20 PREPARED 5/06/08, 14:01:47 INSPECTION TICKET PAGE INSPECTOR: IVR DATE 5/07/08 Harnett County __________ ADDRESS . : 2685 WIRE RD SUBDIV: LINDEN HOLINESS CHURCH CONTRACTOR : BIM BUILDERS LLC PHONE: (919) 894-5741 PHONE: (910) 892-0089 OWNER . . : LINDEN HOLINESS CHURCH-ADD ON PARCEL . . : 12-0555- - -0061- -01-APPL NUMBER: 08-50019437 CP COMMERCIAL ADD & ALTER DIRECTIONS: 401 TO BUNNLEVEL RIGHT ON MCLEAN CHAPEL RD LEFT ON WIRE RD, 1.5 MILES ON LEFT GRACE CHRISTIAN MINISTRIES T/S: 02/18/2008 08:18 AM DJOHNSON --_____ STRUCTURE: 000 000 17'X16' CLASSROOM ADD ON/1/2 BATH ETC FLOOD ZONE . . . : FLOOD ZONE X PERMIT: CBCO 00 CP BUILDING COMMERCIAL

RE: Foundation Investigation & Recommendations

Linden Holiness Church

Harnett County, North Carolina Building Permit #: 08-50019437

SITE SKETCH LINDEN HOLINESS CHURCH N.T.S.

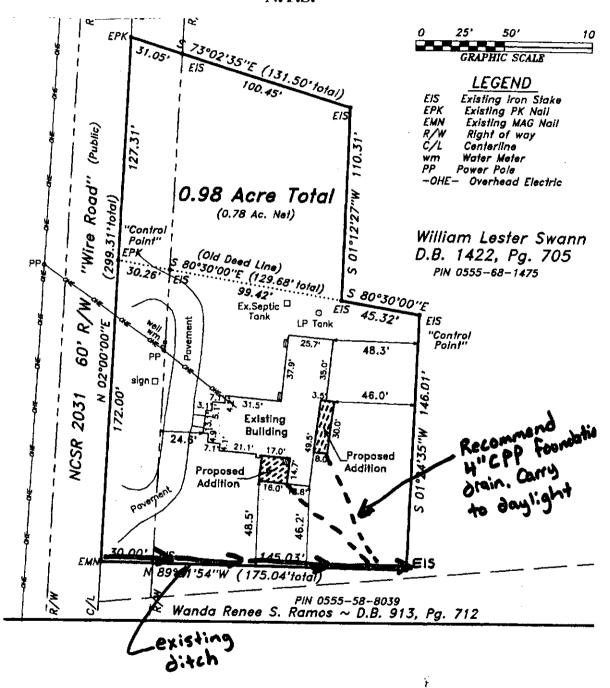
The soils were probed with a No. 6 rebar to identify any soft soil conditions. Almost the entire footing for the two planned additions of the structure was found to be very soft.

The upper 18 to 24 inches of subgrade soil visually classifies as an Organic SILT (OH), damp, and is dark brown to grey in color. The subgrade soils from below the strata described above to approximately 36 inches below the surface visually classifies as Silty SAND, coarse in texture, wet, and is yellow/brown in color.

Within 30 minutes of performing several small borings to a depth of 36 inches, the ground water was recorded at 18 to 22 inches below the ground surface along both footing locations.

- Based on the observations above and the anticipated loading of the structure, in order to provide adequate support for the proposed additions to the existing structure we make the following recommendations:
 - 1. The footing location identified on the attached sketch should be undercut to a minimum 24" below the proposed base elevation of the concrete footing and a minimum width of 36".
 - Install one of the following woven geotextile fabrics per manufacturer's recommended installation procedures across the entire bottom of the footing excavation (min 36" wide).
 - a. Terratex GS
 - b. Mirafi 500x
 - c. TNS W200
 - This undercut shall then be backfilled with NCDOT #57 stone in 12" compacted lifts a minimum of 24 inches thick.

4. In addition, the concrete footing shall be reinforced with three rows of No. 3 rebar centered beneath the foundation wall and 2 inches off the bottom of the footing.

**It is also recommended that a minimum 4" corrugated plastic pipe (CPP) drain be installed at the lowest corner of each footing to act as a foundation drain in conjunction with the #57 stone. The 4" CPP should be laid on adequate grade to facilitate drainage to a point at which the pipes can daylight.
